Protest Decision

Matter of: R J Dean Construction, LLC

File No.: 2022-001

Description: Gunsmithing Renovation

FLOOR PLAN

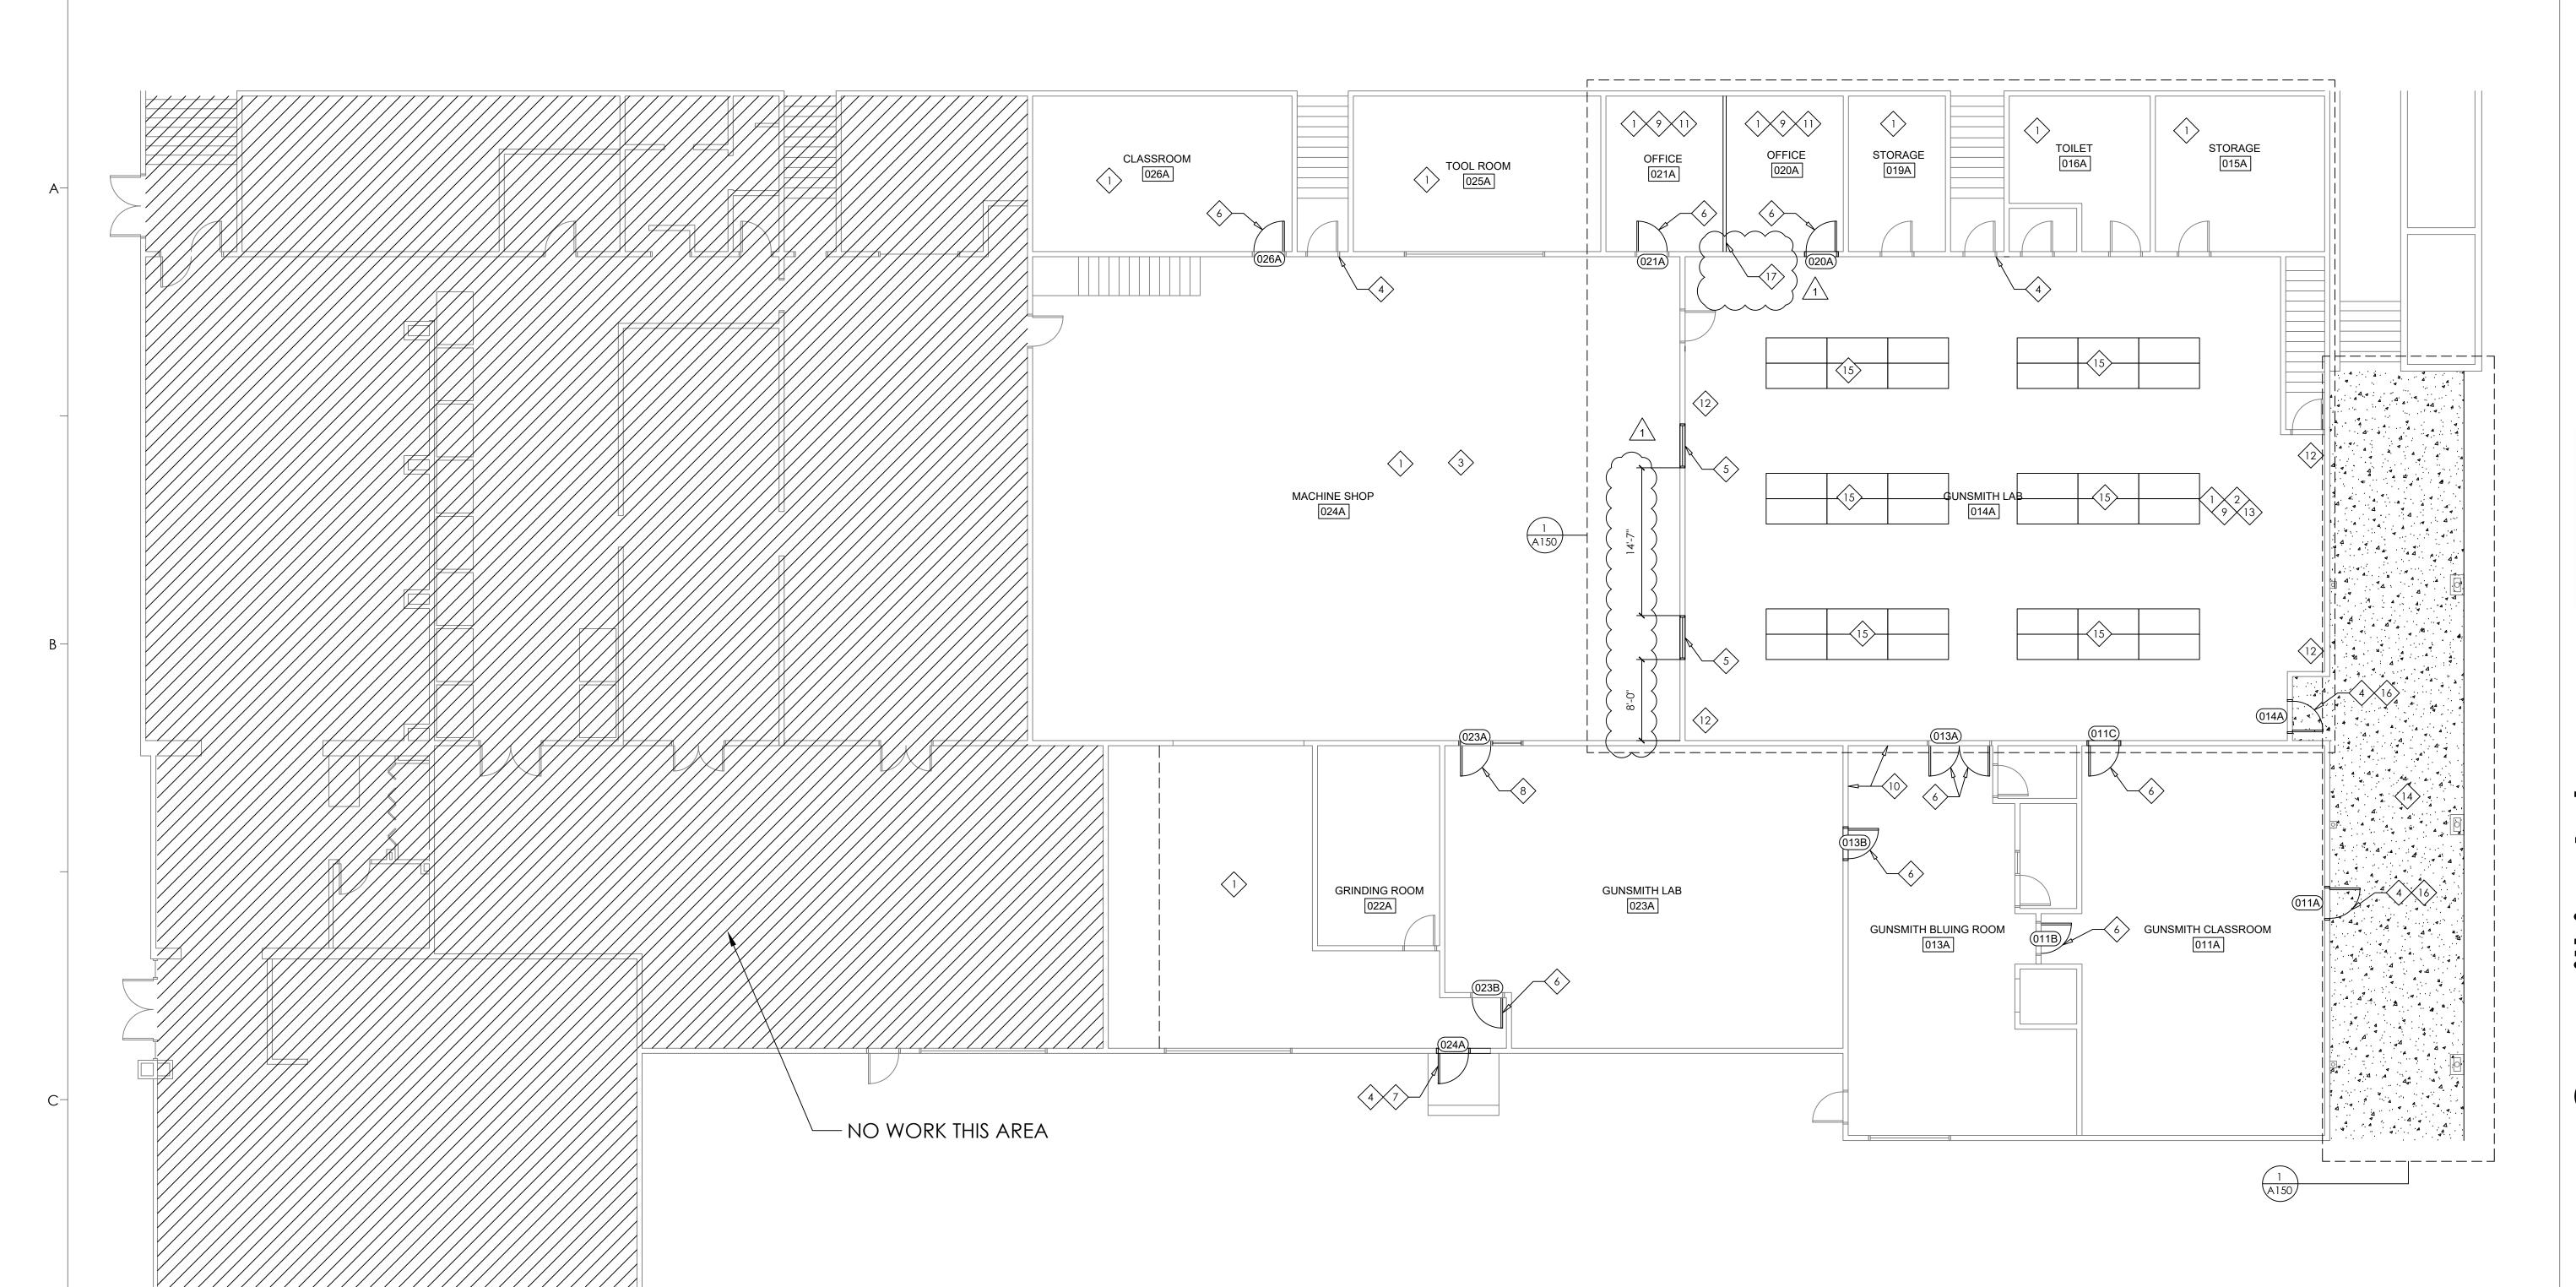
B. A100 Floor Plan:

Delete Floor Plan A100 and substitute the attached Floor Plan A100 revision dated 07/21/21. Revisions include:

- 1. A key note for the wall type is called out on A100. "New Wall 3-5/8" Metal Stud, 16in. O.C., ½" Gypsum Wall Board both sides, to metal deck above."
- 2. Window locations have also been dimensioned on A100.

PARTIAL CEILING & ROOF PLANS

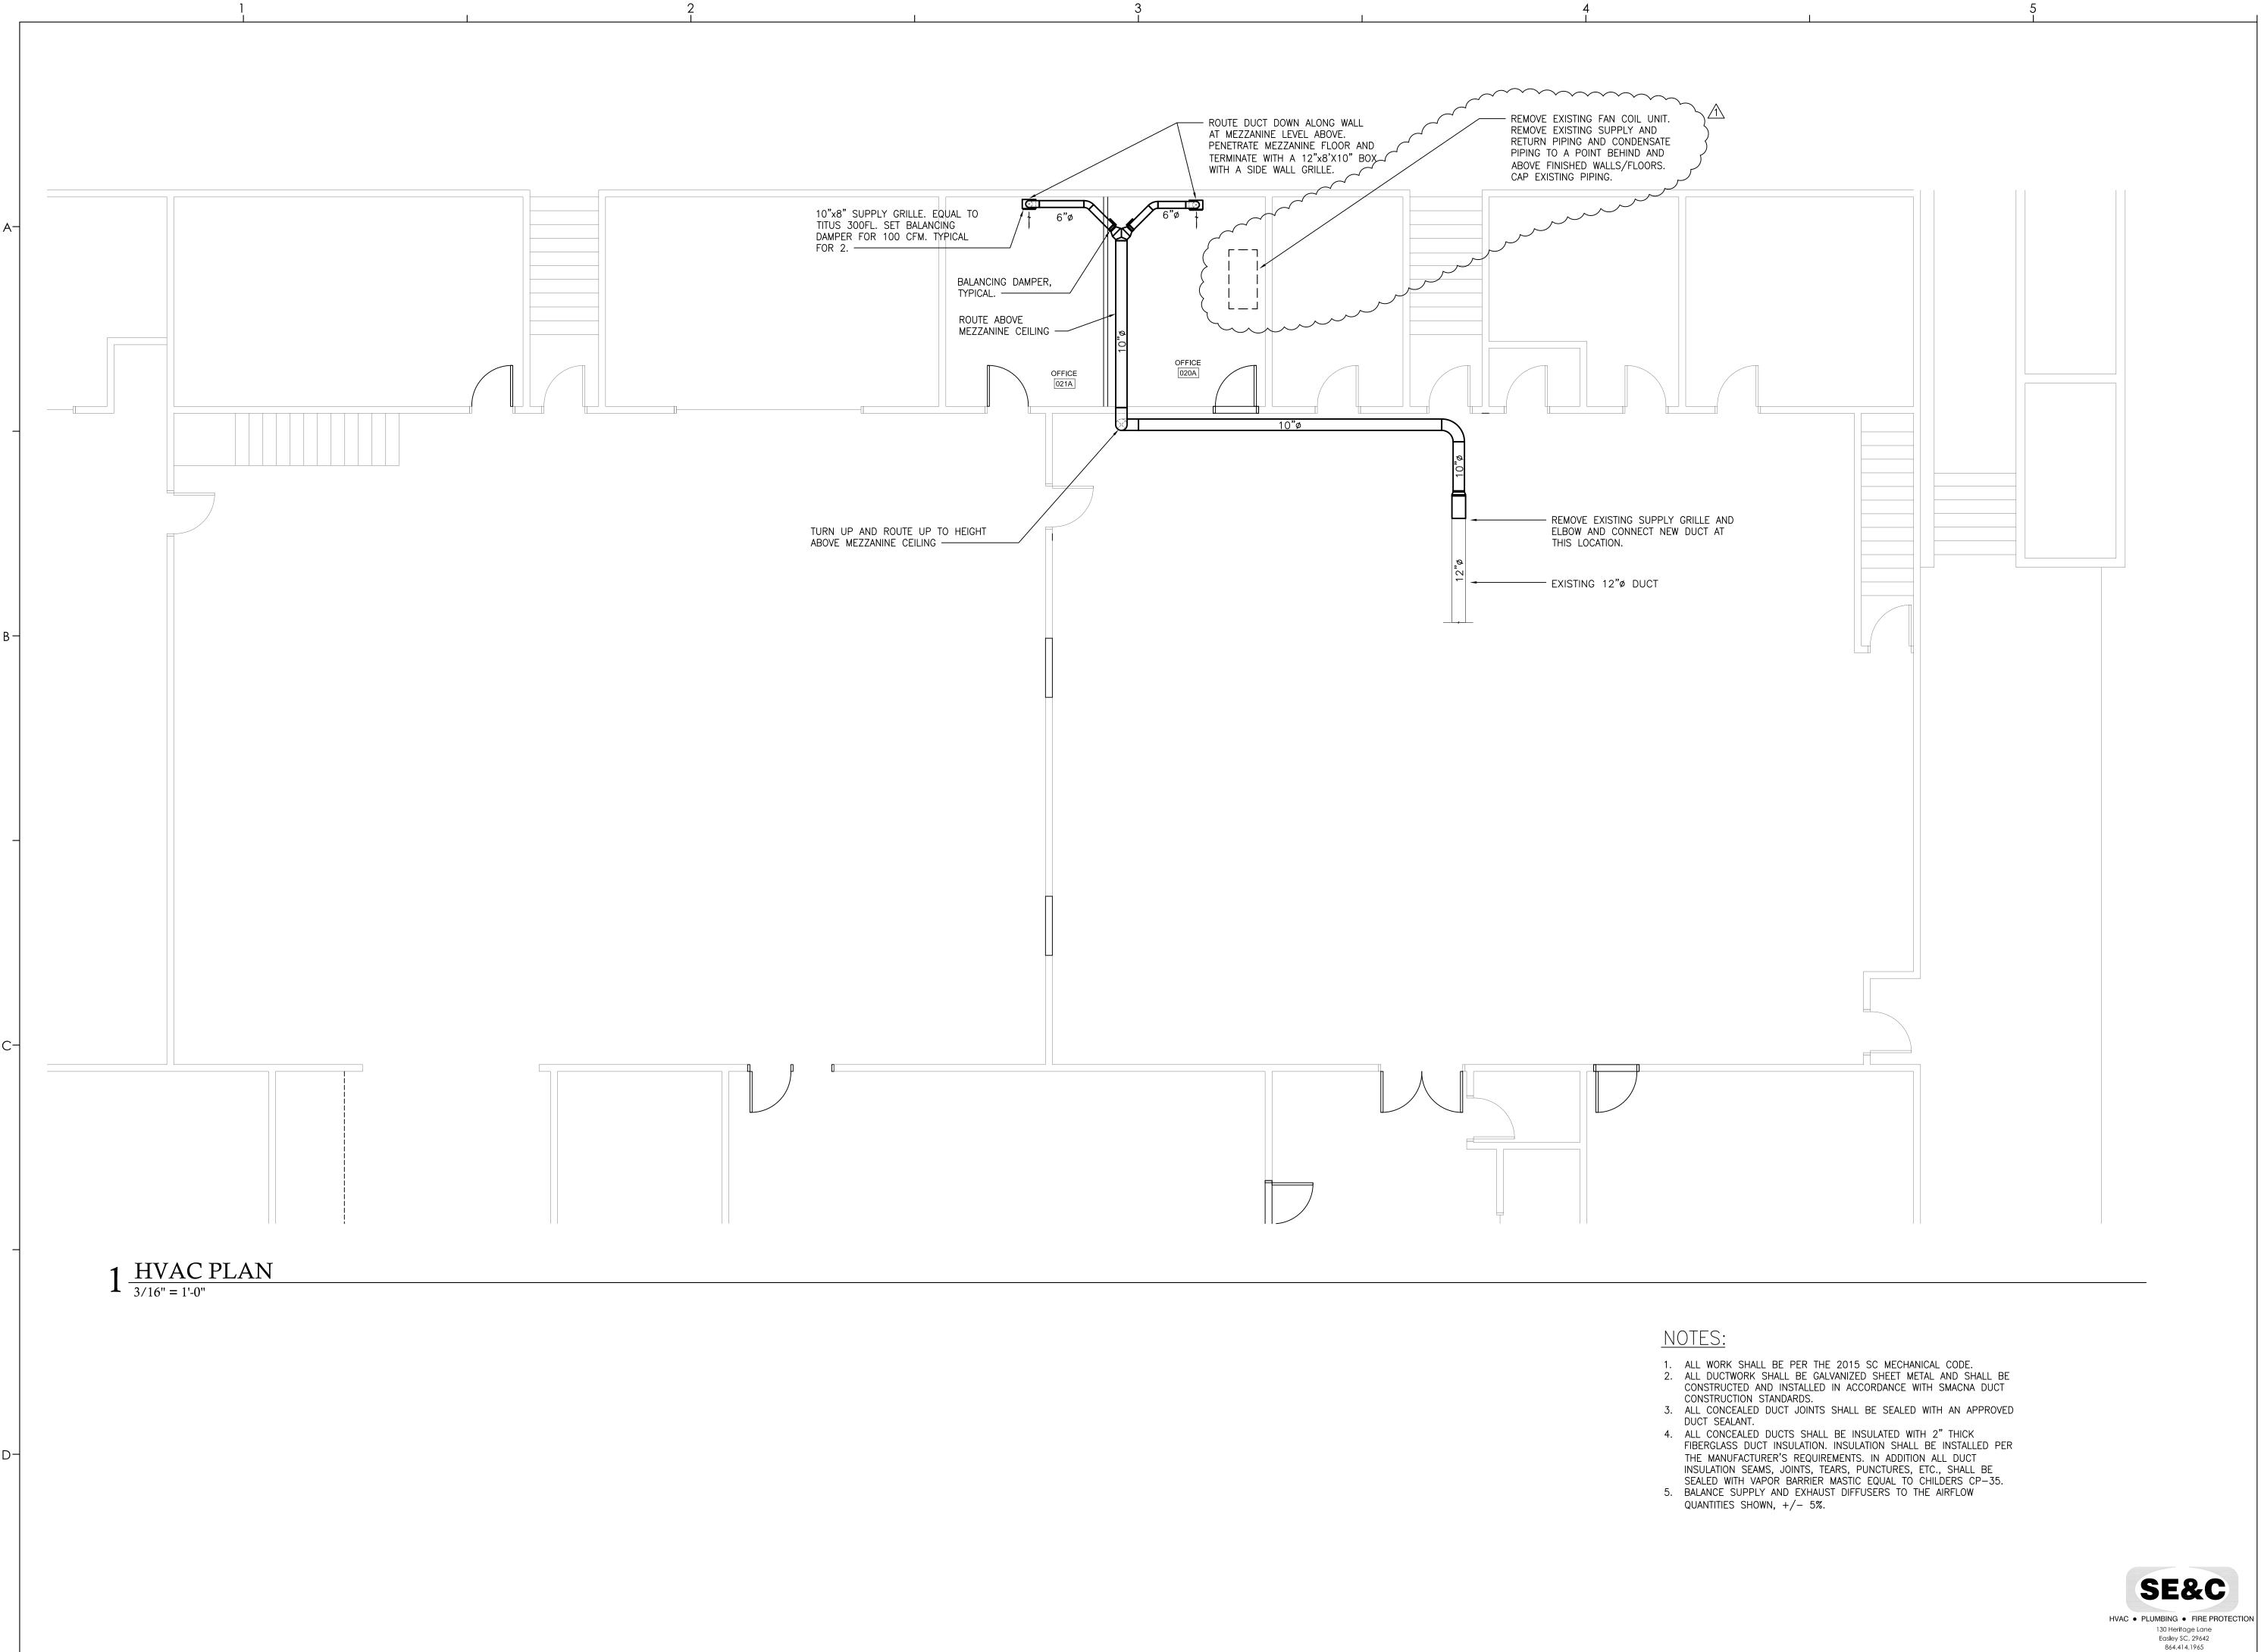
C. A150 Partial Ceiling & Roof Plans:

Delete Partial Ceiling & Roof Plans and substitute the attached Partial Ceiling & Roof Plans revision dated 07/21/21. Revisions include:

1. Note 3 has been revised.
